Access Compliance Report Public Rights-of-Way (Curb Ramps)

Main Street: VANDERLIP_AVE Cross Street: HOLT_AVE Location: SE

ADA ID: RPRK220124115929 Ramp Type: Type 4 - Parallel Initial Pass/Fail: Fail Overall Compliance: No Severity Score: 30

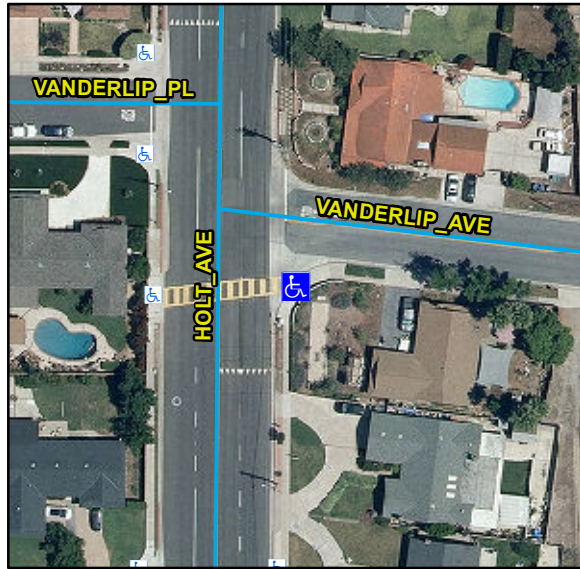
Compliance	Description	Data	Compliance	Description	Data
N/A	Ramp Length LT (in)	106	N/A	Ramp Length RT (in)	92
Yes	Ramp Width LT (in)	94	Yes	Ramp Width RT (in)	94
Yes	Ramp Run Slope LT (%)	6.9	Yes	Ramp Run Slope RT (%)	4.3
No	Ramp Cross Slope LT (%)	7.5	No	Ramp Cross Slope RT (%)	6
N/A	Landing Present	N/A	N/A	DWS Provided	N/A
N/A	Landing Length (in)	N/A	N/A	DWS Contrast	N/A
N/A	Landing Width (in)	N/A	N/A	DWS Length (in)	N/A
N/A	Landing Run Slope (%)	N/A	N/A	DWS Full Width	N/A
N/A	Landing Cross Slope (%)	N/A		DWS Offset Type	N/A
N/A	Landing Movement Obstructed?	N/A	N/A	DWS Offset Left (in)	N/A
	Landing Movement Type	N/A	N/A	DWS Offset Right (in)	N/A
N/A	Landing Shared	N/A			
N/A	Clear Space	Yes			
N/A	Clear Space To Crosswalk (in)	N/A			
N/A	Marked Crosswalk 1	No	N/A	Marked Crosswalk 2	Yes
	Crossing 1 Direction	N		Crossing 2 Direction	W
	Marked Crosswalk 1 Width (in)	N/A		Marked Crosswalk 2 Width (in)	145
N/A	Ramp Inside Crosswalk 1	N/A	N/A	Ramp Inside Crosswalk 2	No

Remove & Replace Curb Ramp With Two New Directional Ramps or Equivalent. Restripe Crosswalk.

R304.5.3, STD 1115
